MEMORANDUM

RE: Hillview Crossing Townhomes – Storm Water (TLI #14-3592)

PRELIMINARY
GRADING AND DRAINAGE ENGINEERING DESIGN REPORT
*FOR CALCULATIONS USING USDA/NRCS WinTR-55 PROGRAM &
IN ACCORDANCE WITH CITY OF MISSOULA PUBLIC WORKS STANDARDS*

Revised: April 9, 2019

DRAINAGE FLOW PRO-RATED MAP
HILLVIEW CROSSING TOWNHOMES
CITY OF MISSOULA
SECTION 6, T12N, R19W, P.M.M.
MISSOULA COUNTY, MONTANA

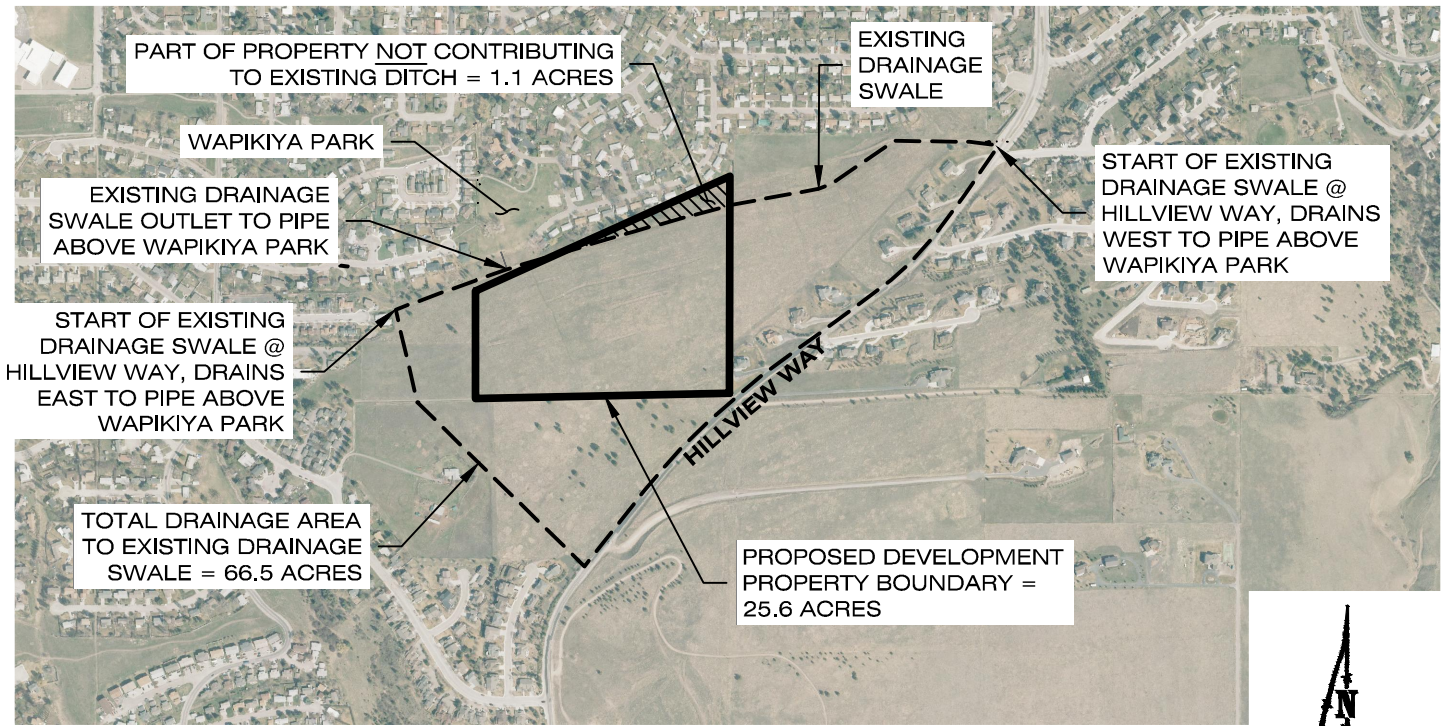
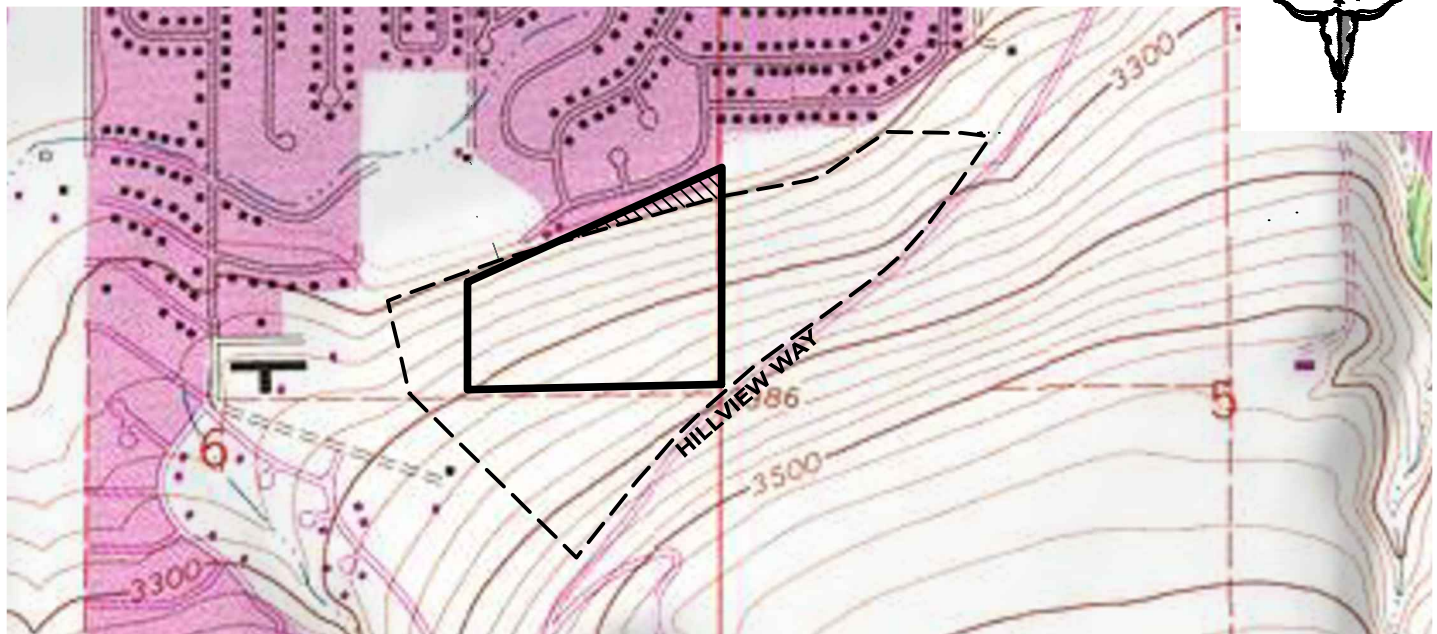
1. Per Troy Monroe, PE’s email dated October 9, 2018, we revised the pro-rated flow in Section 5.2B. This included removing the area of the property that doesn’t contribute to the existing collection ditch. The revised exhibit and calculation show the actual contributing “pro-rated” flow to be 2.57 cfs (not 2.7 cfs as previously submitted).

PERCENTAGE OF CONTRIBUTING FLOW FROM PROPOSED DEVELOPMENT AREA VERSUS OVERALL CONTRIBUTING FLOW TO EXISTING SWALE = $(25.6 \text{ ACRES} - 1.1 \text{ ACRES}) / (66.5 \text{ ACRES}) = 36.8\%$

ALLOWABLE PRO-RATED FLOW TO BE RELEASED FROM SITE = $(7 \text{ CFS}) * (36.8\%) = 2.57 \text{ CFS}$

OUTLET STRUCTURE SCHEMATIC (not to scale)

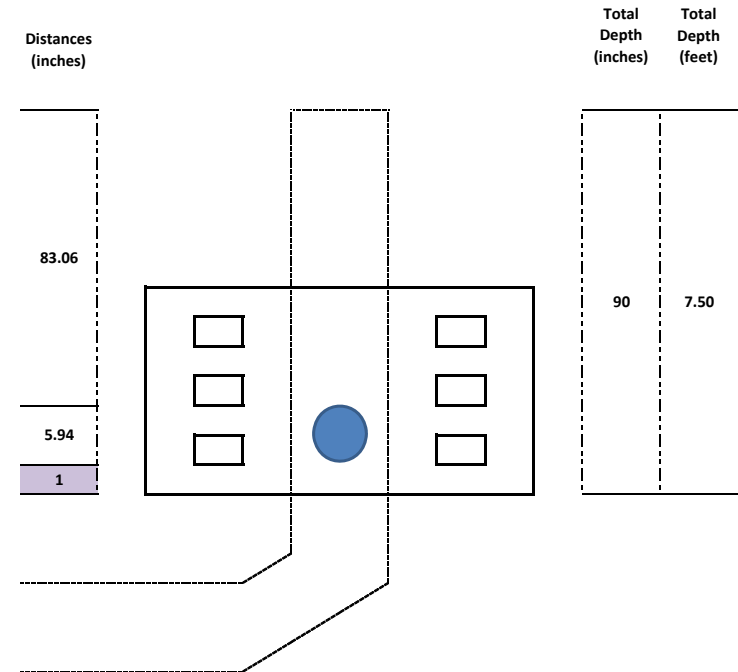
4. As requested by City Council, we evaluated the outlet structure from the stormwater vault that will lead to the park and sized an orifice that will limit stormwater flows as discussed in the original report and amended with this submittal per Troy’s email.

Orifice Sizing			
Orifice Diameter =	5.94	inches	
C_d =	0.62		
dist. to next orifice	83.06	inches	distance from top of orifice to top of overflow pipe
h =	86.03	inches	
A =	0.19	ft ²	
Q =	2.56	cfs	
O_n =	1	orifice(s)	number of orifices
Q_{ST} =	2.56	cfs	flow through an individual orifice
Q_T =	2.56	cfs	total flow through total number of orifice(s)
q_o =	2.57	cfs	maximum flow rate based on pro-rated flow

Acceptable Release? YES

STORMWATER COLLECTION VAULT
EXHIBIT

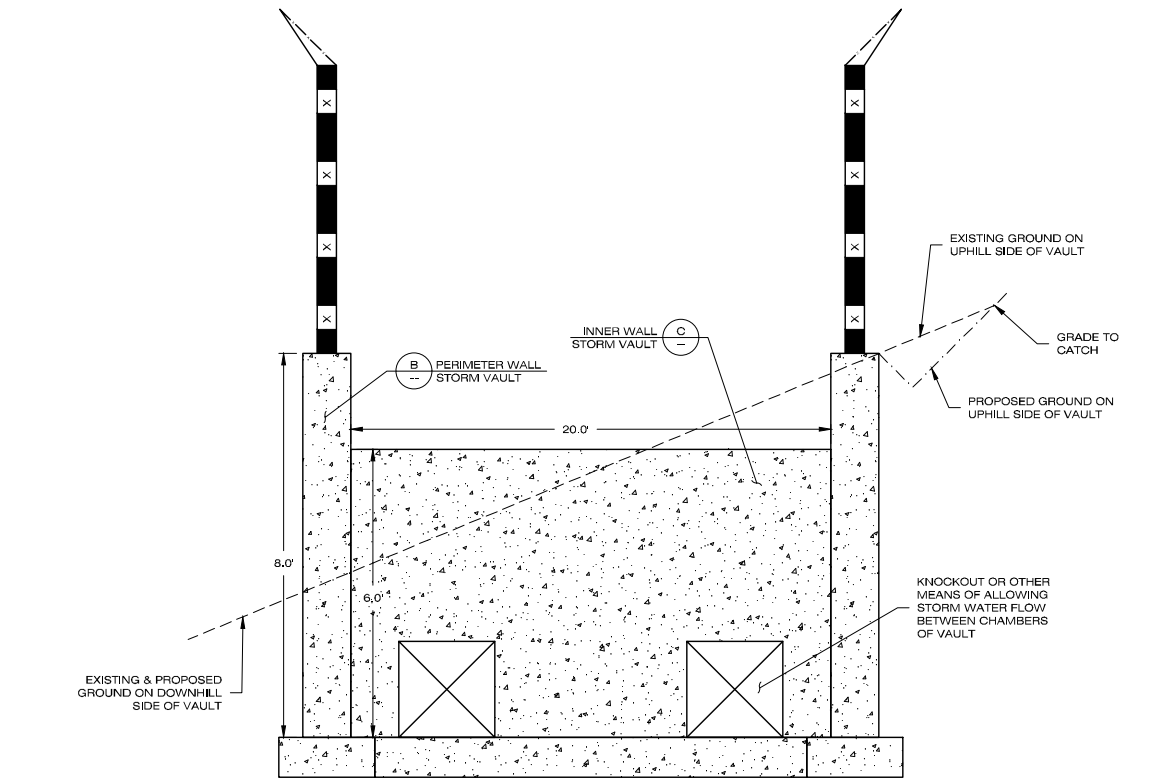
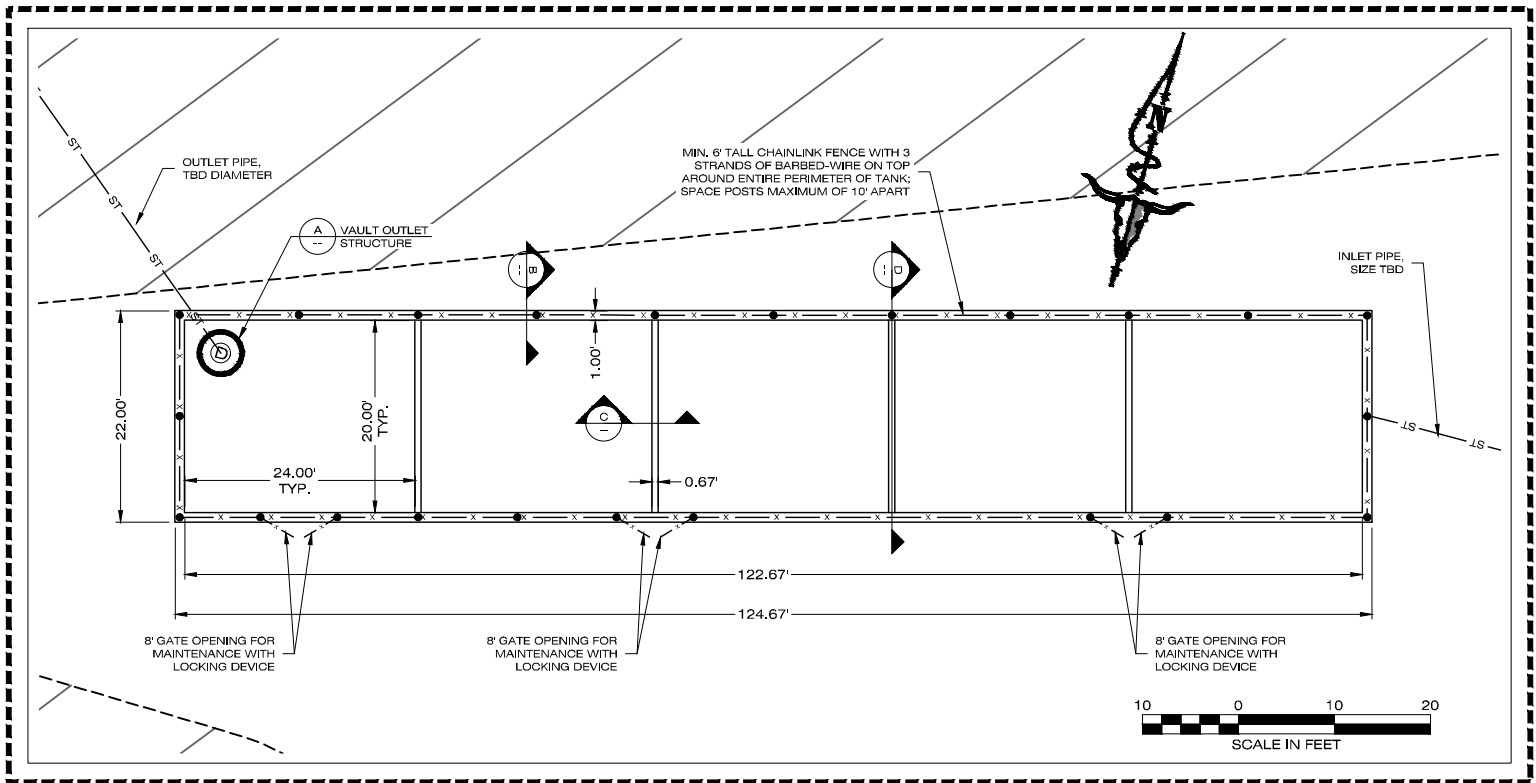
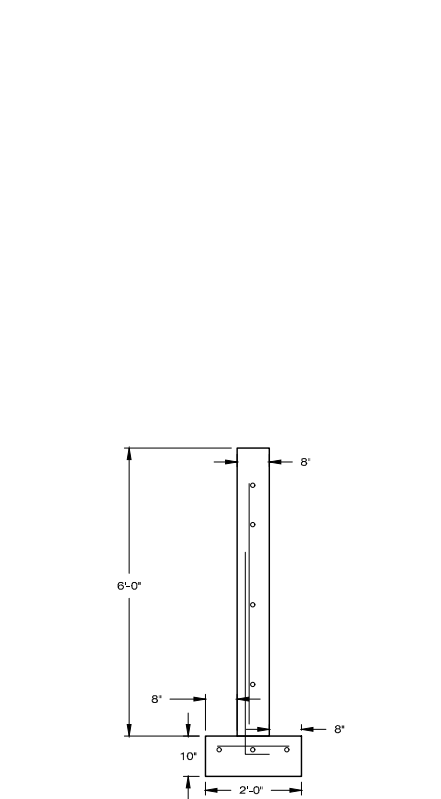
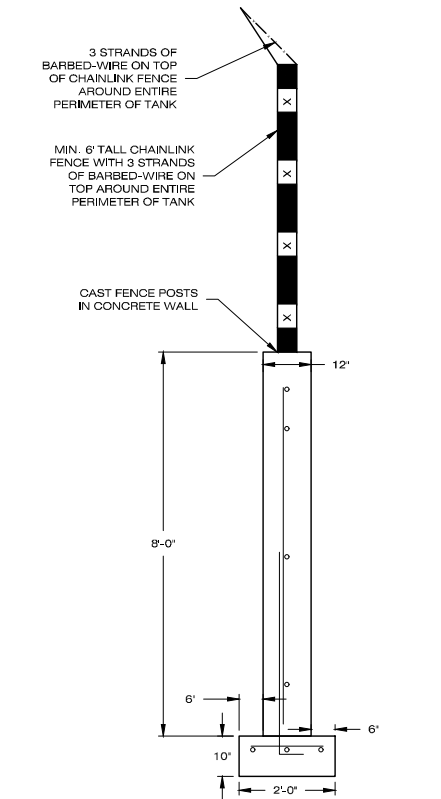
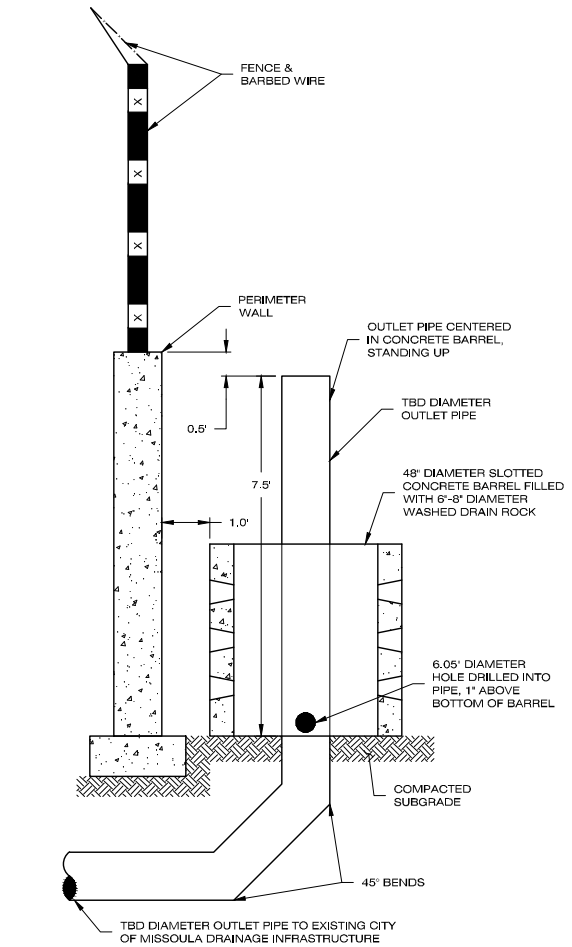
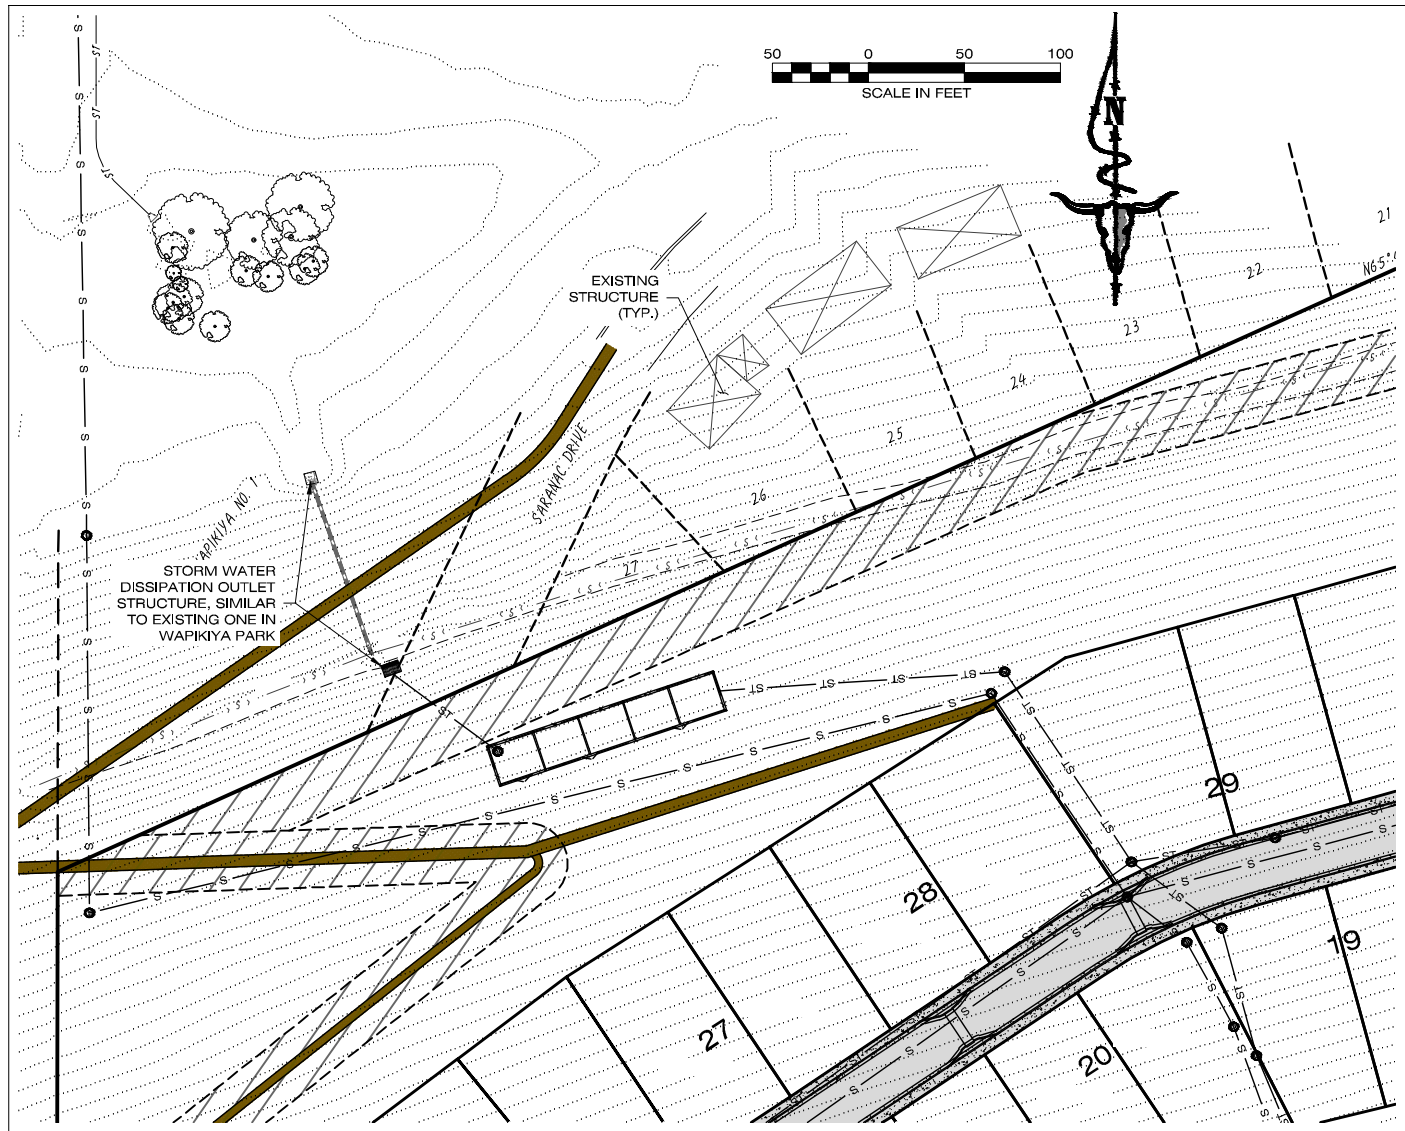
5. As requested by City Council, we also have included an exhibit and diagrams of how a vault could store the waters generated by the current proposal. This includes a vault that has been preliminarily analyzed structurally by Eclipse Engineering and an outlet structure orifice that will limit flows to the allowed 2.57 cfs, while storing the required volume.

The storage volume of the stormwater vault as shown on attached exhibits or details is shown calculated here:

Actual Stormwater Vault Storage Volume = $(120 \text{ feet}) \times (20 \text{ feet}) \times (7.5 \text{ feet}) = \underline{18,000 \text{ CF}}$
